Mitchell Field Boating Access Improvements

MaineDOT WIN 23082.00 & 23472.00

Addendum #2

August 19, 2025

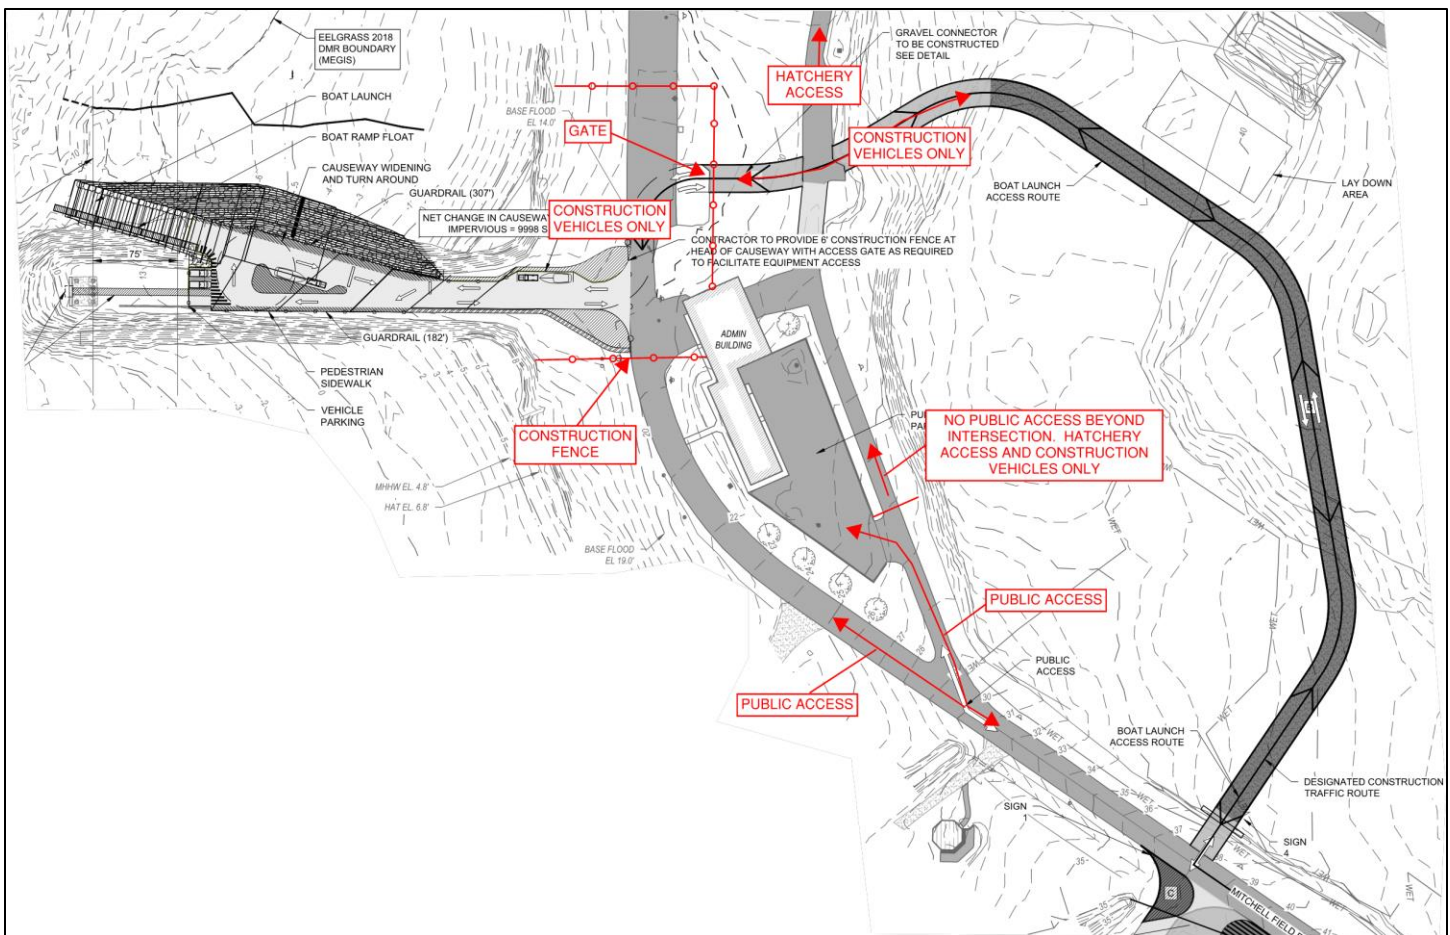
Question #8

Will site access be restricted during construction and demolition?

The Mitchell Field property will remain open to the public, but public vehicle access will be restricted beyond the Admin Building. The paved road along the waterfront, from the admin building to the hatchery, will be blocked off and restricted to construction vehicles only. The road located behind the admin building will be for hatchery access and construction vehicles only beyond the parking area that is adjacent the admin building. The public will have access to the parking lot and the access road toward shore up to the limits of the construction fence. Refer to the figure below for guidance:

1 CROSS - SECTION
SCALE: 1" = 1'-0"

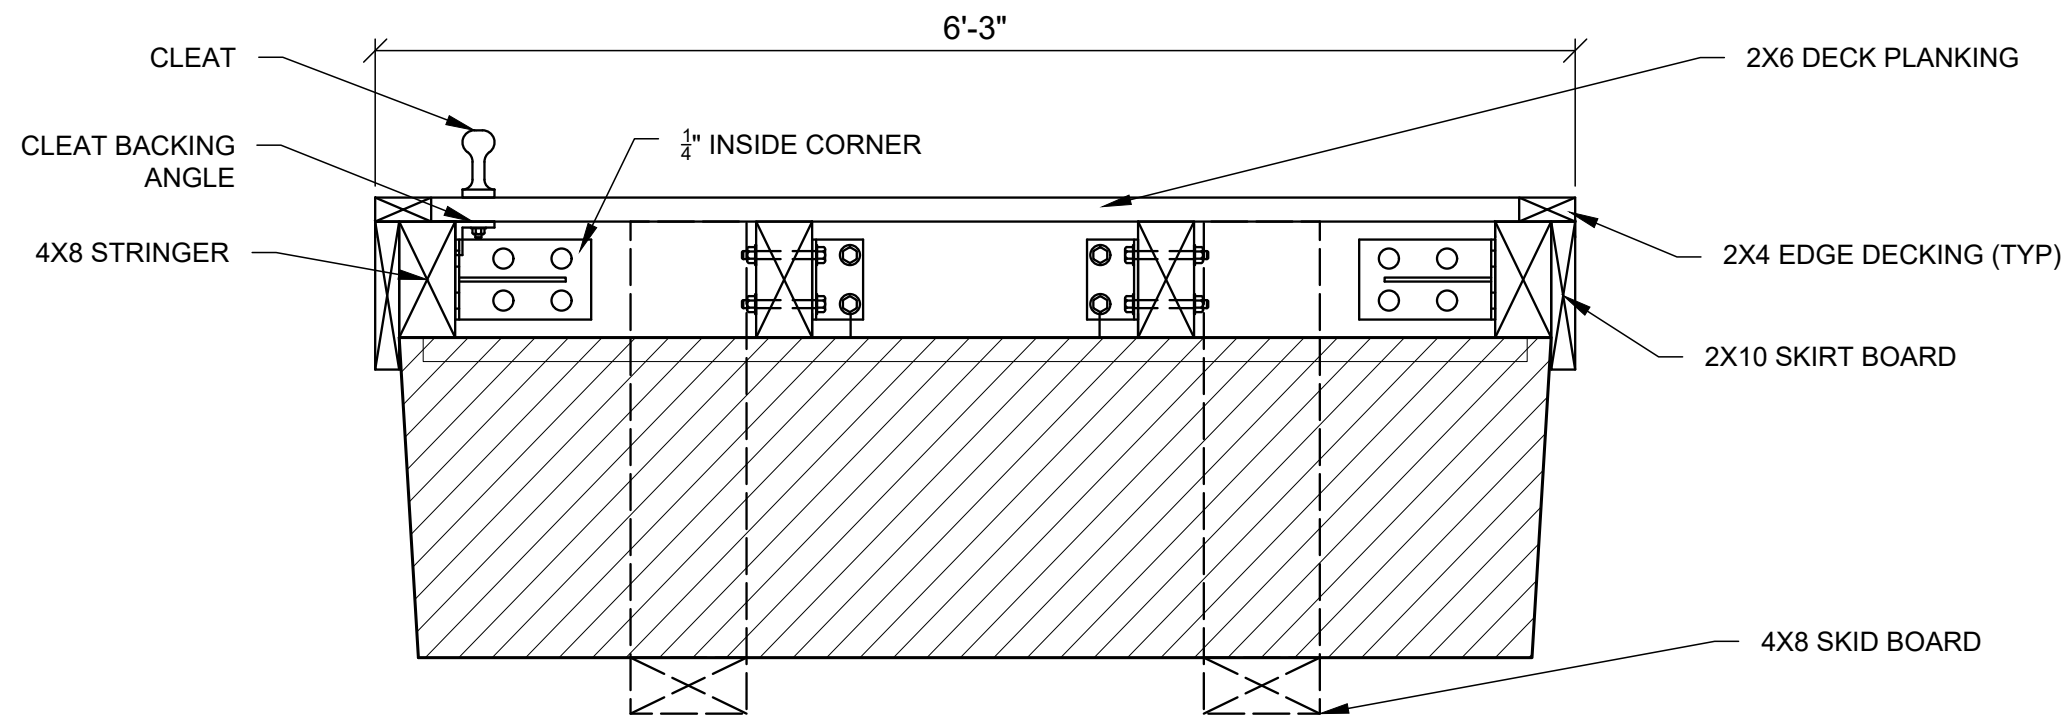
Question #14

Please provide a cross-section detail of the 6' x 20' floating docks.

Refer to Item #1 of A. CHANGES TO BID DOCUMENTS. A cross-section detail of the floating docks has been provided.

PILE SOCKET DETAIL
SCALE: 3/4" = 1'-0"

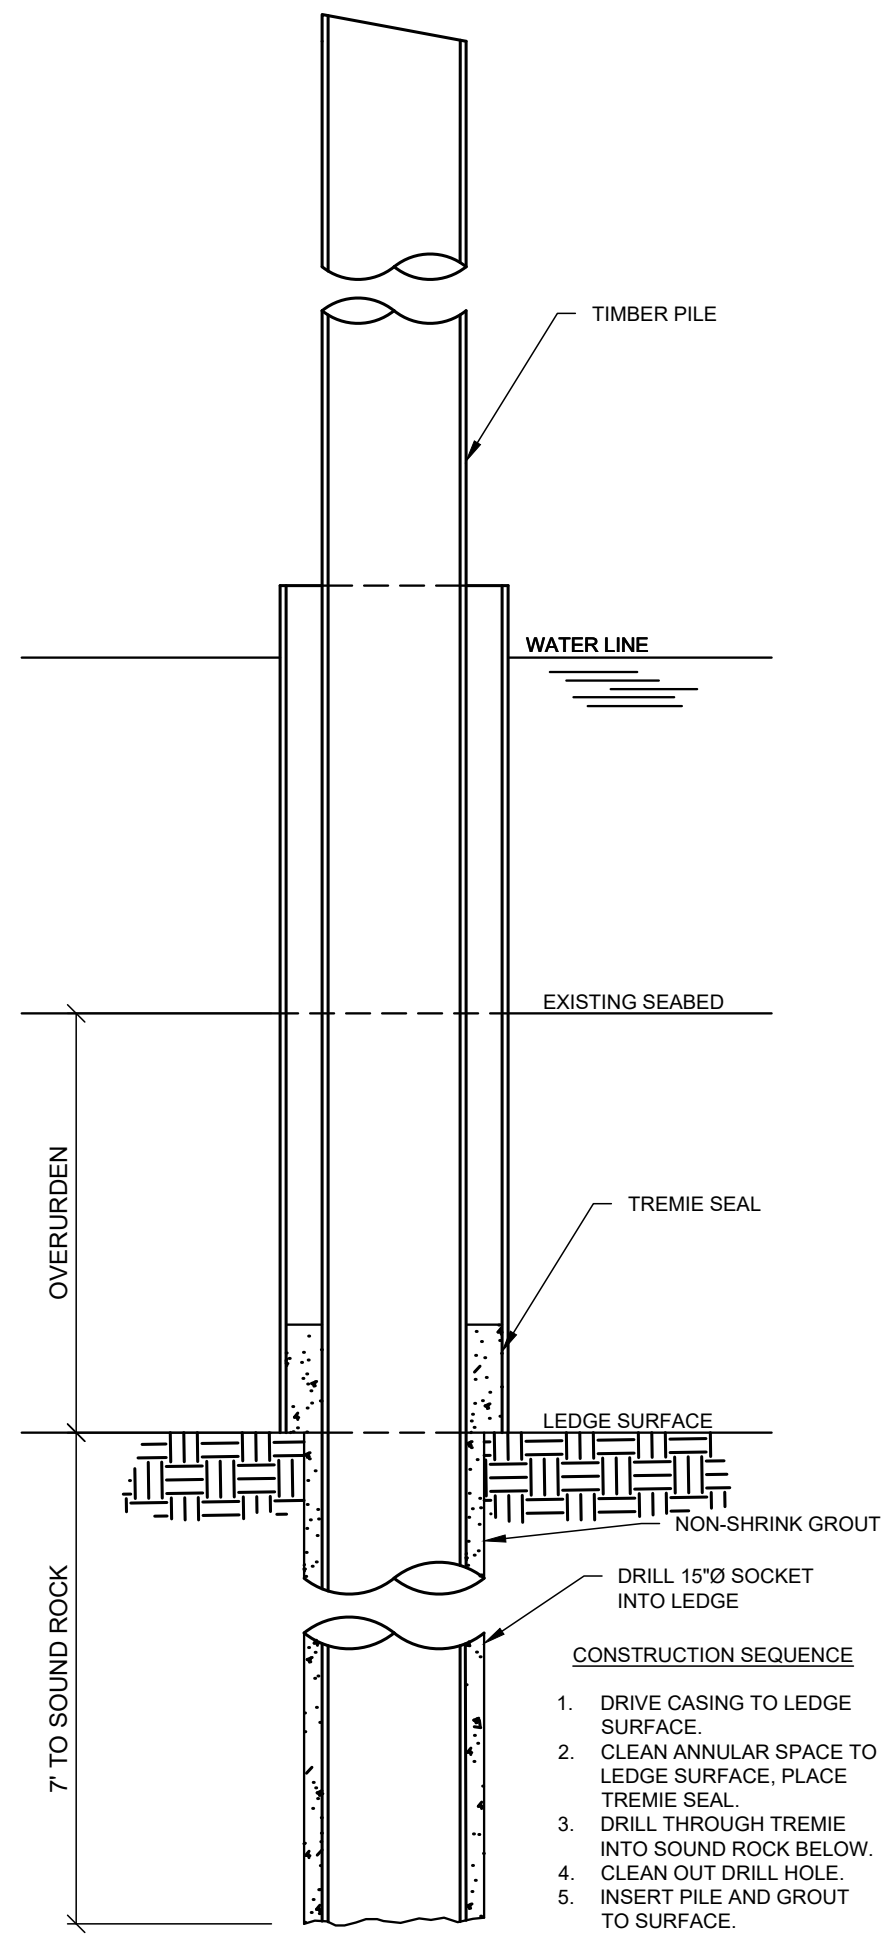
Question #13

Please provide a detail of the rock socket.

Refer to Item #1 of A. CHANGES TO BID DOCUMENTS. A detail of the rock socket has been provided.
